Anton W Dubrau
Vendome Consultation - Let's Optimize the transfer between AMT and STM

This brief looks at the Vendome Accessibility project, which attempts to make the STM and AMT Vendome station accessible, including a connection to the new MUHC hospital and the residential area to the North.

Existing vs proposed transfer concourses at Vendome Station

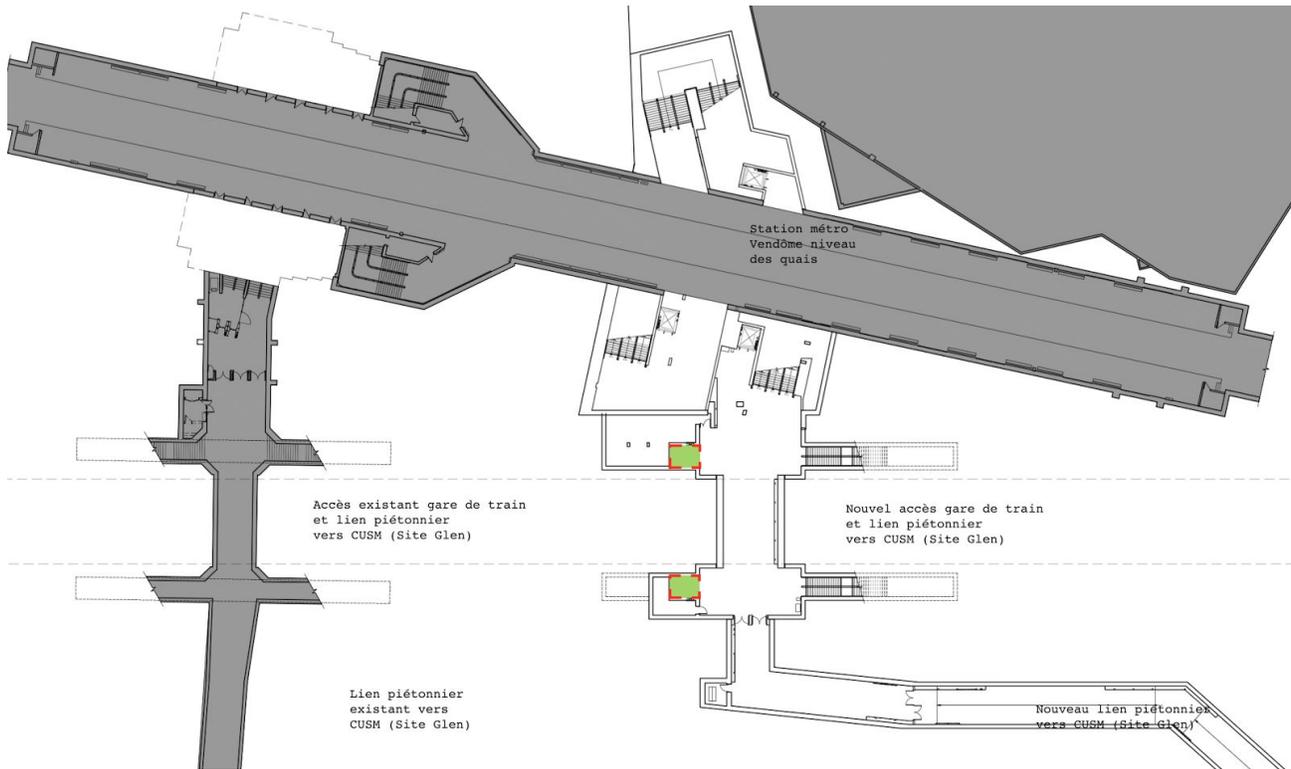
AMT-STM transfer: long, many steps, no escalators

Also for comparison, the existing concourse at Vendome as a transfer length of 88m/105m. The total number of steps is around ~60 steps.

The existing transfers are shorter because they don't turn onto themselves. They have fewer steps both because the metro mezzanine is lower, and because the train concourse is higher. On the other hand, the existing transfer is far on the West of both the train and metro station, which is not ideal.

The plans for the new concourse effectively squander the opportunity given by the smaller physical separation between train and metro station, and the better position along the platforms, by providing a transfer-walk which is worse.

Proposed plan: stairs only are on the Eastern side of the tunnel. There should be One set of stairs on the Western side.

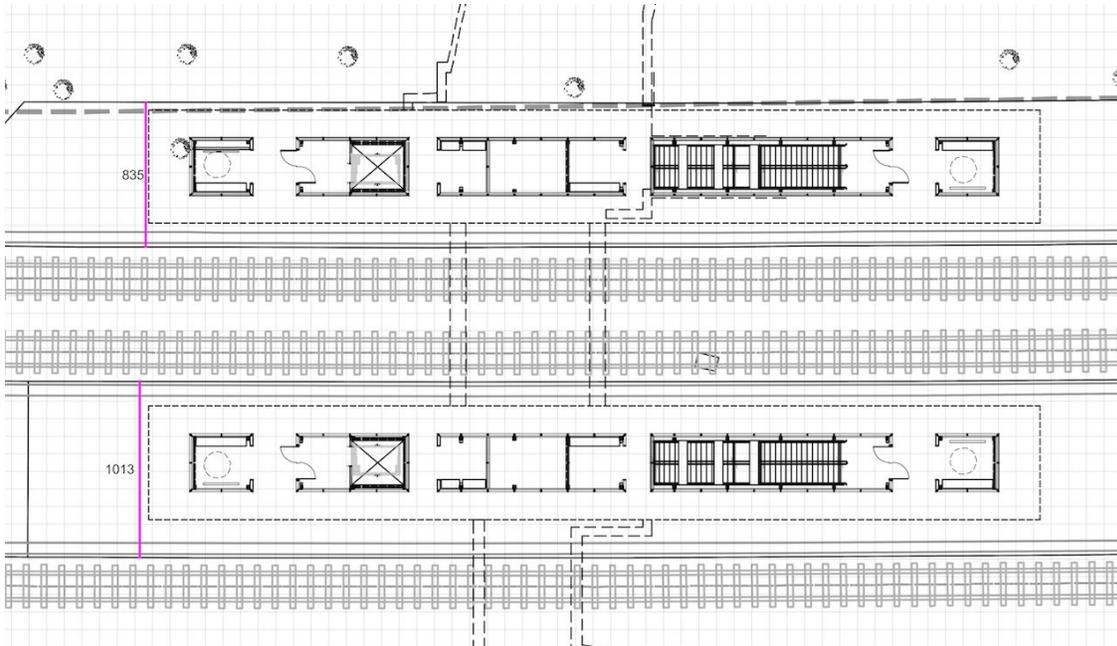
A related issue is that for the new AMT connection, the stairs only go up East from the tunnel. It would be preferable for stairs to go both East and West from the tunnel, just like the old concourse. This would decrease the required along-platform walk.

From the plans provided (which were given without scale), we can infer the platform width to be 8.35m and 10.13m, which should be sufficient for one set of stairs and an elevator side-by-side. Additionally, the stairs and elevators can be slightly angled relative to the platform, providing more space:

STM Southern Platform area (left), AMT tunnel area (right). Note identical stair patterns.

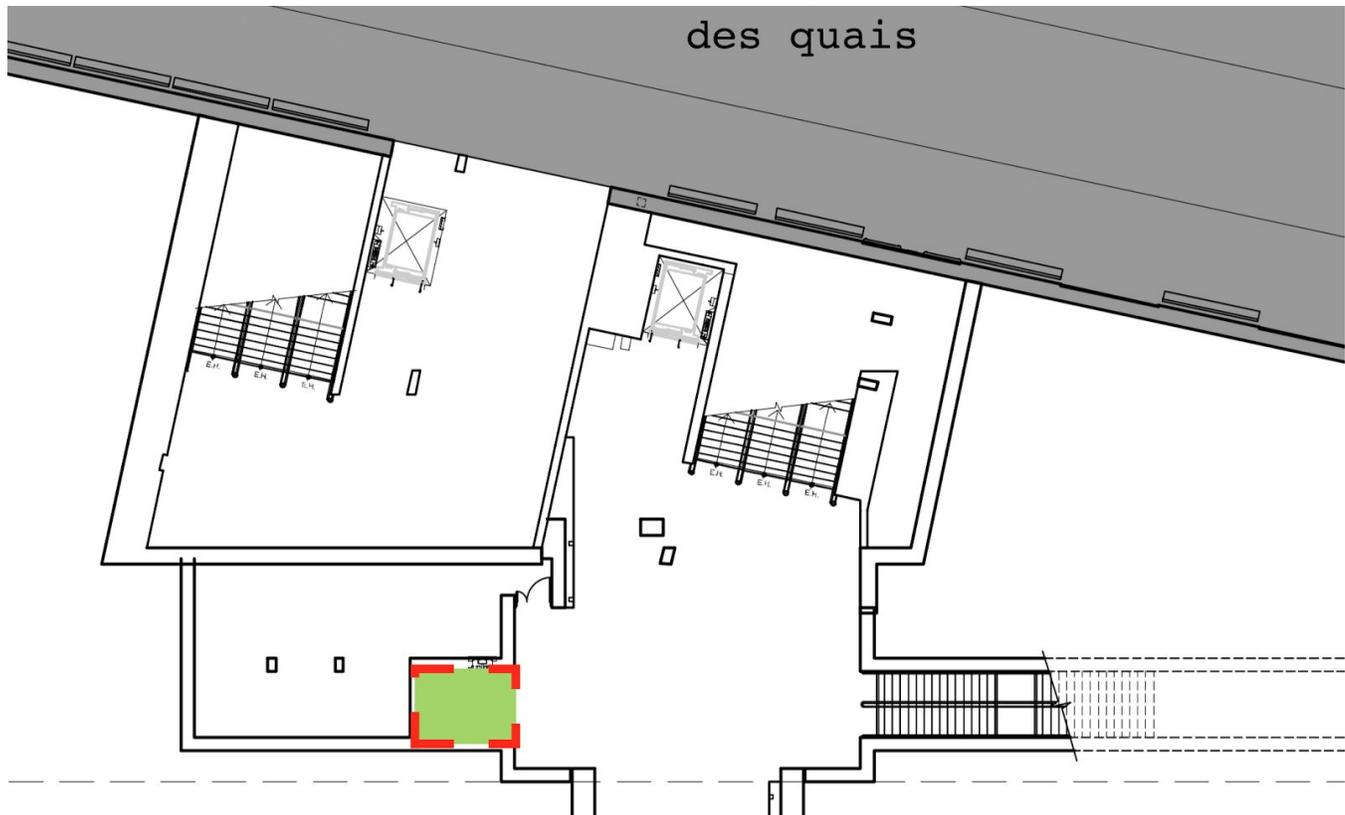
From the documentation provided, it appears that the Southern metro platform and the AMT tunnel are on the same level. Since there is no connection, passengers have to walk up 31 stairs, walk through the doors connecting the AMT and the STM areas, and walk down 31 stairs to end up only one wall away from where they started.

At the consultation session on February 21, Matthew MacLauchlin asked why there is no connection between those areas. The answer was that there is a difference in level, and we were promised that the volumetric plans would be provided that would show that. The plans provided do not answer that question. They do, however, seem to indicate that the level is the same, given that the stairs in the AMT and STM areas appear identical.

The lack of a door at this point adds significantly to the transfer burden, both for abled bodied users (number of stairs and walking distance) and for people who need to use elevators (it would be possible to use 1 elevator instead of 3 to transfer).

Current Plan of the Underground Level, showing STM area (left) & AMT tunnel (right)

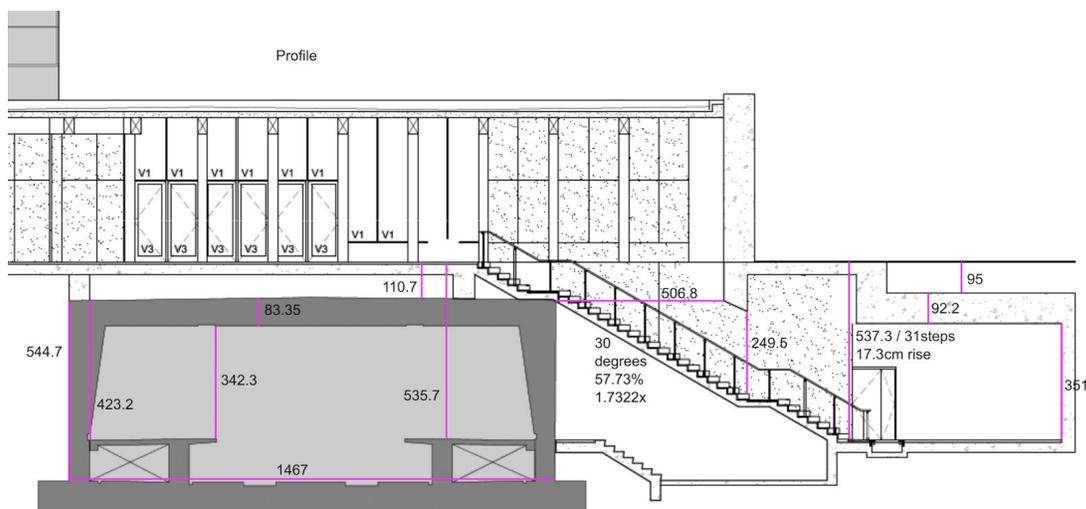
From the provided plans these appear to be at the same level. Even if they are not at the same level, it is possible to raise or lower the AMT tunnel level to match the STM level. This should be easily attainable, as there is 5.36m height difference between the STM platform level and the ground level (at which AMT trains should be), plenty of space for the tunnel and the necessary construction to hold the tracks above it. If this is not possible, refer to section 5.3 for a design allowing different levels.

Proposal 1.1 (underground level)

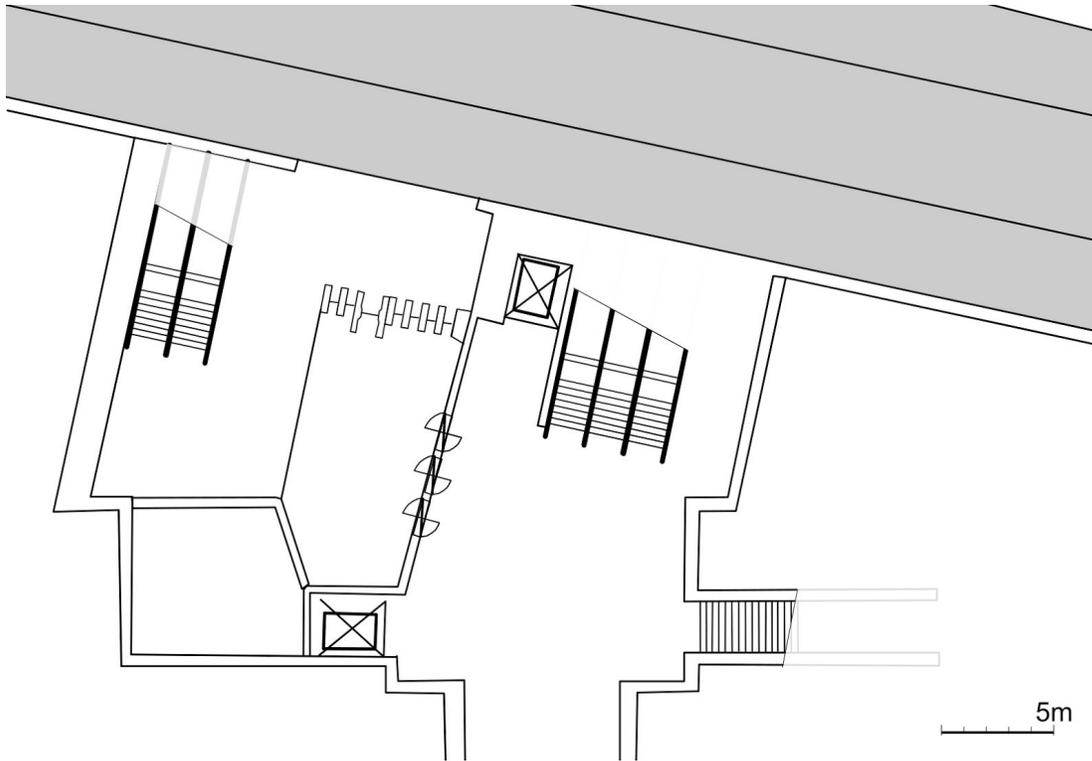
Assuming the STM and the AMT tunnels are on the same level, we can create a connection between them as follows:

- The various design elements (doors, stairs, turnstiles) are merely copied from other plans, at the correct scale.
- The overall physical envelope is taken from the current design, no exterior wall was moved (although some space of the utility room in the bottom left corner was turned into a public area).
- The three sets of stairs on the left was reduced to two, because most passengers will use the shown turnstiles, and can alternatively use the other shown stairs.
- The elevator inside the paid area was removed, thus this design only has 4 elevators overall. This elevator is redundant, removing it maintains all the same accessible paths (while removing the requirement to take 3 elevators for any transfer involving the Eastbound Metro platform).
- The areas that are not shown are largely unaffected, and can use the current plan.

Profile of current plans, with elevator envelope superimposed, showing conflict

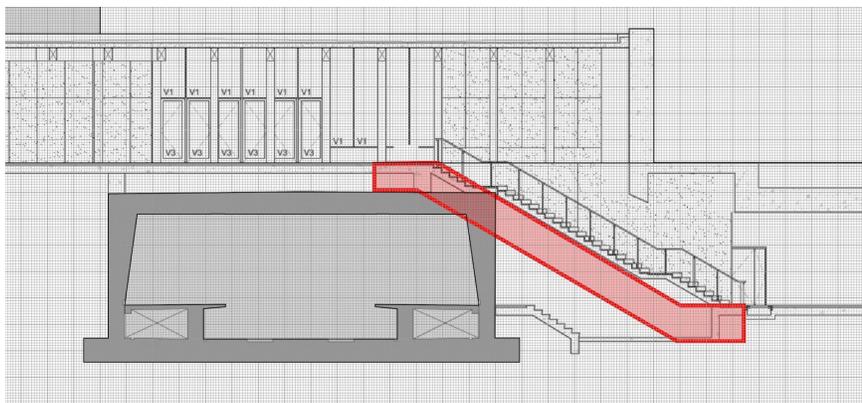
At the consultations it was claimed that there is simply not enough space to insert escalators, due to lack of “vertical space”. Indeed, if one looks at the profile, and considers the clearance requirements for elevators (about 2m at the top and bottom, about 1m down from the stairs [7]), it’s easy to see that the stairs from the level above the current metro tunnel down to the AMT tunnel/Southern STM platform will go inside the envelope of the tunnel:

*Stairs with clearance issues shown in red,
stairs that should not have clearance issues shown in green*

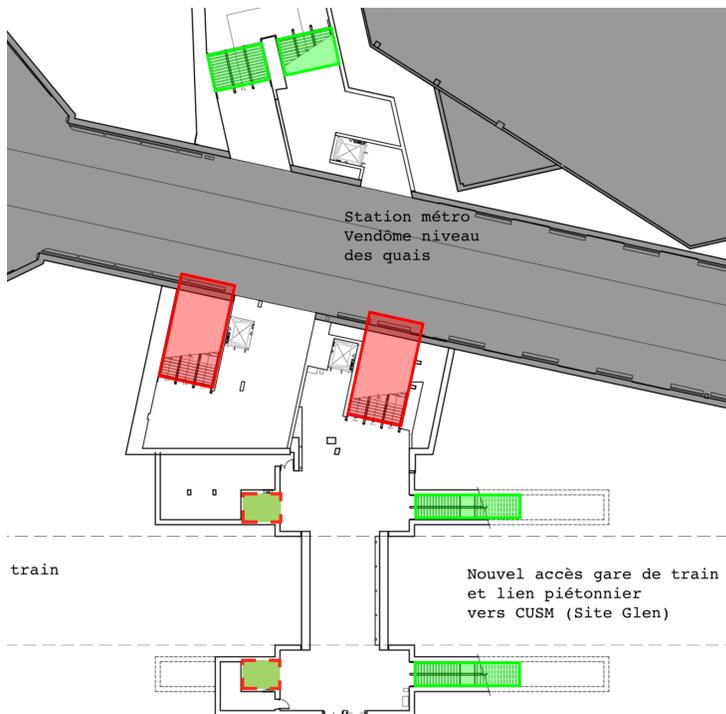
However, this problem only affects the stairs shown in the following diagram in red. All the other stairs have no such clearance issues:

- Move the STM mezzanine level 1m down, so that it will be straight on top of the existing metro tunnel. This has the positive side effect as to reduce the total number of stairs to make a transfer from the North side by a total of 12 steps (6 up, 6 down).
- Refer to the Proposal 1.2, which moves the various stairs left. This provides more vertical clearance (since the "crash wall" and the Vendome metro station are at an angle relative to one another).

Profile assuming the mezzanine is moved down to metro level, with escalator clearance shown. Note the 2m extra horizontal clearance to the crash-wall, by moving the stairs several meters West.

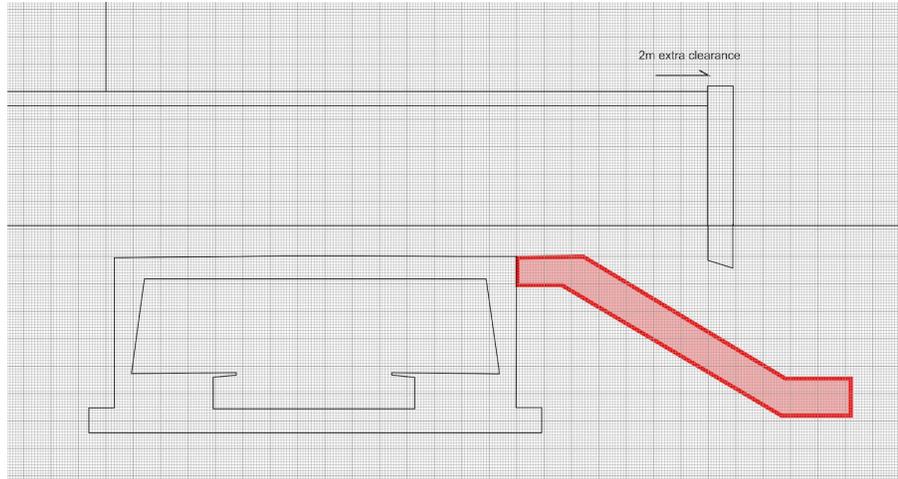
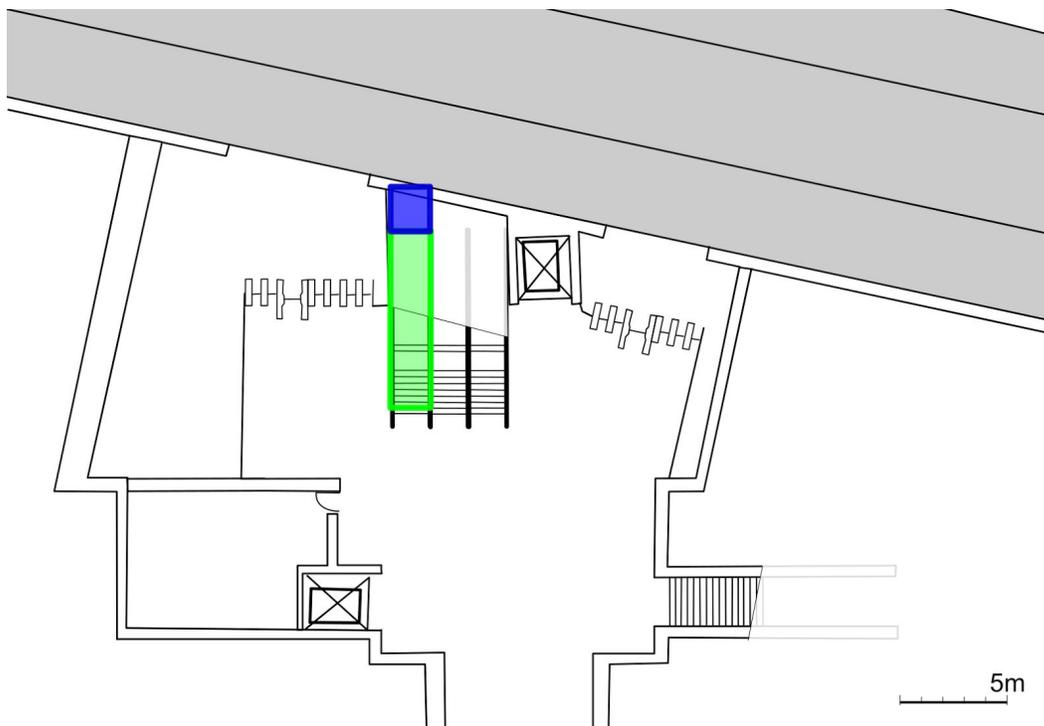
In combination, this should allow adding an escalator for the crucial tunnel/mezzanine connection.

Proposal 2. Location of single upward escalator, with enough 2m clearance (shown in blue) between the Metro tunnel and the escalator

Profile view of Optimizing the Vendome Station transfers

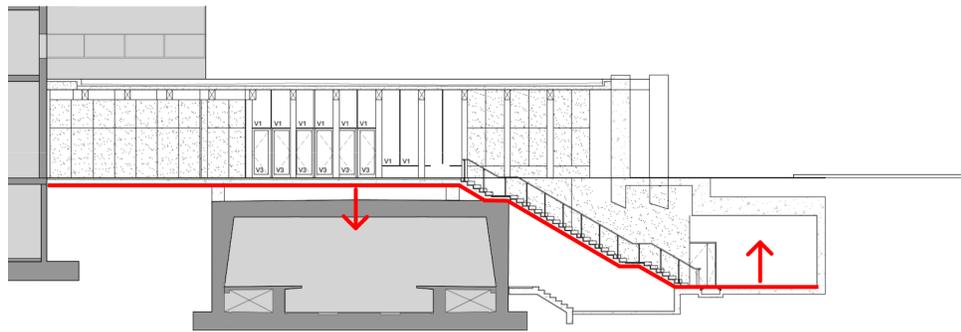
Optimizing this transfer is essentially an exercise in raising the AMT tunnel up, and lowering the mezzanine above the metro tunnel down.

- the total number of stairs required for transfers from the Northern metro platform to the AMT goes down (at twice the rate of of moving the levels),
- The constraints due to the small horizontal space between the metro tunnel and the crash-wall will reduce,
- Long flights of stairs will be turned into several shorter flights of stairs, which require less effort,
- It may become feasible to have a ramp between the two shown levels, allowing an elevator-less access between the MUHC and the residential area to the North of Vendome,

Proposal 3, profile view. The height is meant to be to scale (using 1m grid), the horizontal features are approximate. The boxes represent elevators.

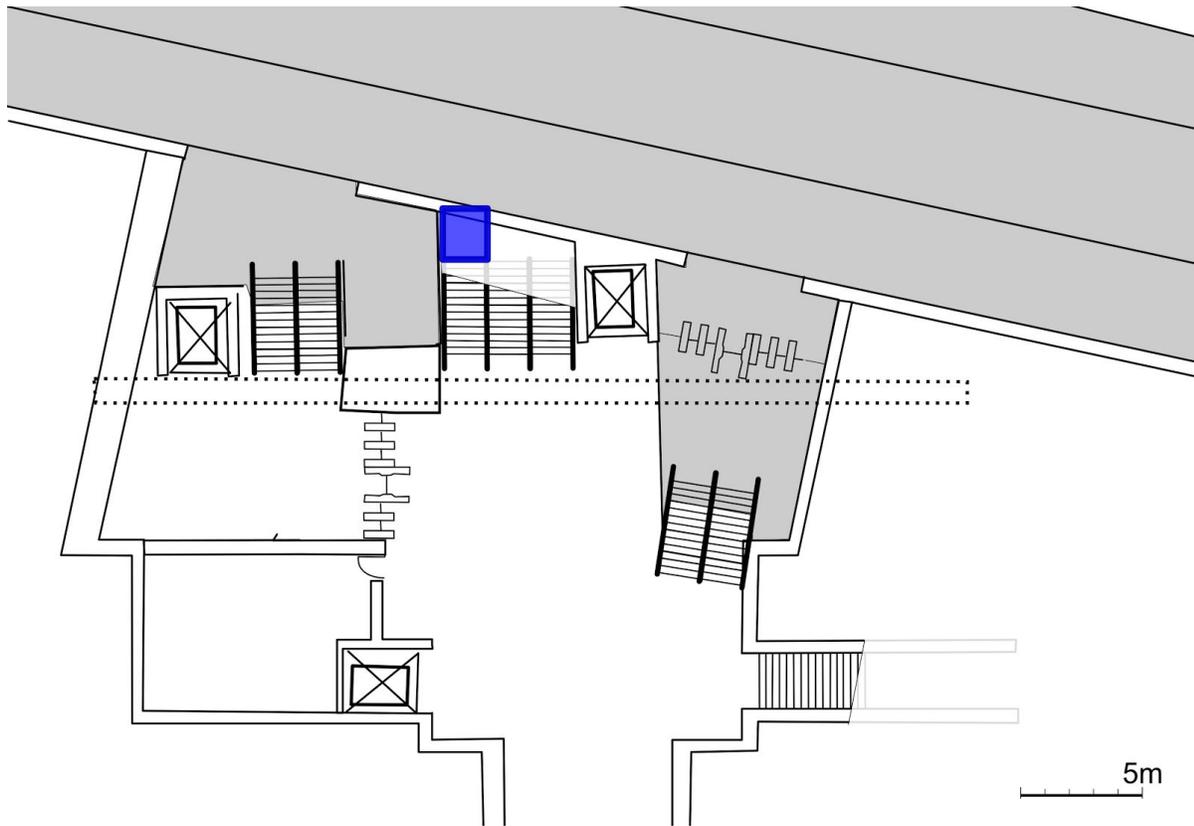
The above design is an “extreme”, which split the ~4.40m distance between metro platform-level and the ground-level into two equal, 2.20m split-levels. Since the stairs are all relatively unconstrained, this design should allow any height-difference between the AMT and the STM level between 2.20m all the way down to 0m, in which case this would be equivalent to Proposal 2.

Note that we are using five elevators again. If the height difference between the AMT and STM level was small (up to ~100cm), then it would be possible to use a large L-shaped ramp along the wall on the left, instead of an elevator.

Proposal 3. (underground level). The darker area represent areas that are At the STM level. The white areas represent areas that are at the AMT level. The blue area represents the vertical clearance required for an escalator. The dotted bar is the crash wall.
